Remarks

Appl. No. 10/663,102
Amdt. Dated December 9, 2004
Reply to Office November 16, 2004

Figure 2(a)

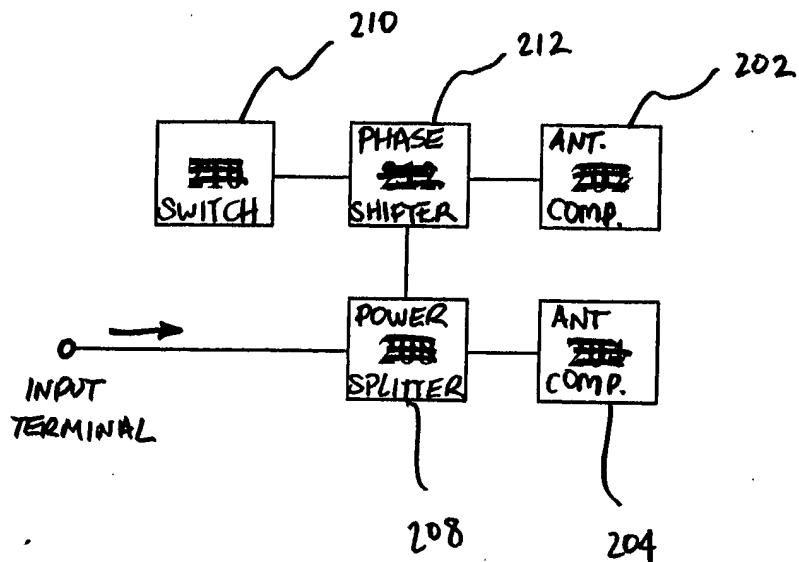
The Examiner objects to Figures 2(a), 2(b) and 2(c) for failing to show descriptive legends. Revised version of Figures 2(a), 2(b) and 2(c) are submitted herewith which show descriptive legends. Hence, reconsideration and withdrawal of this objection is respectfully requested.

Applicant submits herewith a revised versions of Figures 2(a), 2(b) and 2(c).

Figure 2(b)

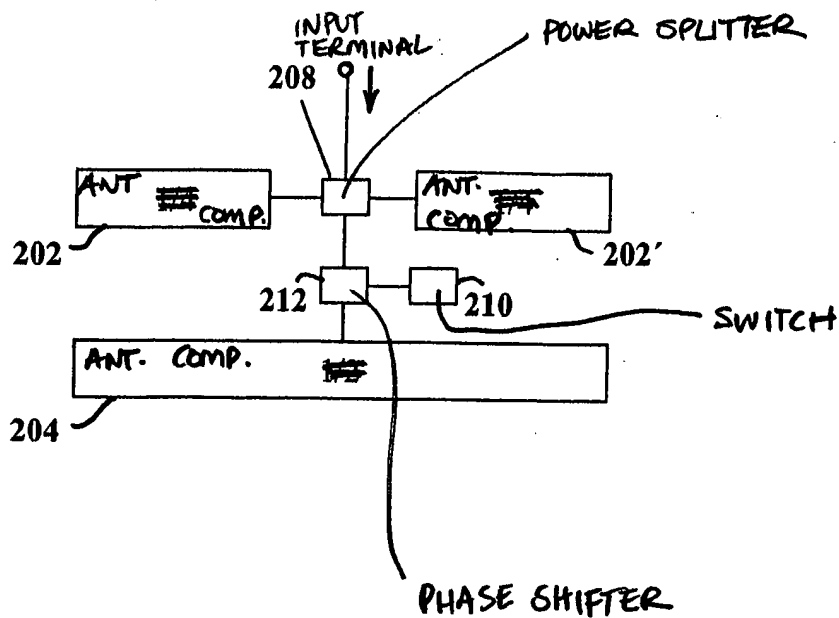
MAKE 208, 210, 212 BOXES BIGGER

Figure 2(c)

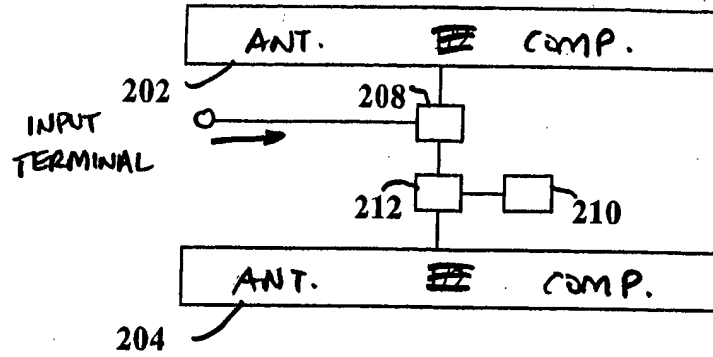
SAME CHANGES AS FIG. 2(b) FOR 208, 210, 212
